Title - Sujet Remplacement de l'ASI du CNRC au We Remplacement de l'ASI du CNRC au West Saanich	
Solicitation No. - N° de l'invitation EZ899-221150/B	Amendment No. - N° modif. 005
Client Reference No. - N° de référence du client	Date 2021-11-12
GETS Reference No. - N° de référence de SEAG PW-\$PWY-047-9067	
File No. - N° de dossier PWY-1-44107 (047)	CCC No./N° CCC - FMS No./N° VME
Solicitation Closes - L'invitation prend fin at - à 02:00 PM Pacific Standard Time PST on - le 2021-11-23 Heure Normale du Pacifique HNP	
F.O.B. - F.A.B. Plant-Usine: <input type="checkbox"/> Destination: <input checked="" type="checkbox"/> Other-Autre: <input type="checkbox"/>	
Address Enquiries to: - Adresser toutes questions à: Kyle (PWY), Davis	Buyer Id - Id de l'acheteur pwy047
Telephone No. - N° de téléphone (250) 869-6395 ()	FAX No. - N° de FAX () -
Destination - of Goods, Services, and Construction: Destination - des biens, services et construction: SSC – Dominion Observatory – Victoria, BC

Solicitation Amendment 005 is raised to indicate that:

**WEST SAANICH NRC
UPS REPLACEMENT**

EZ899-221150/B - ADDENDUM #5

ED SINGLE LINE DIAGRAM

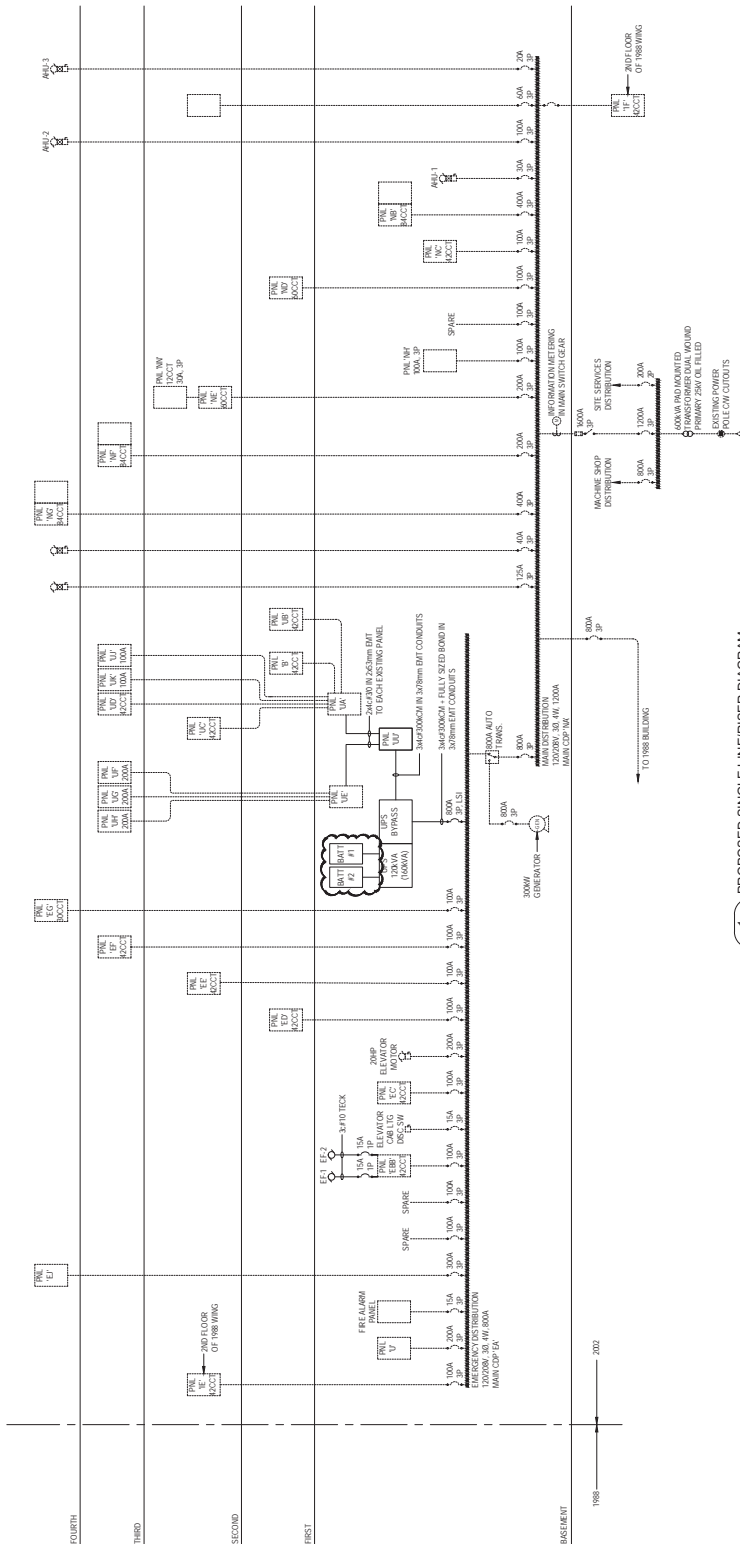
.2 DRAWING E4.1 – REVISED SINGLE LINE DIAGRAM

- .1 Revised UPS as shown, with two battery cabinets connected to UPS using vendor recommended cables.
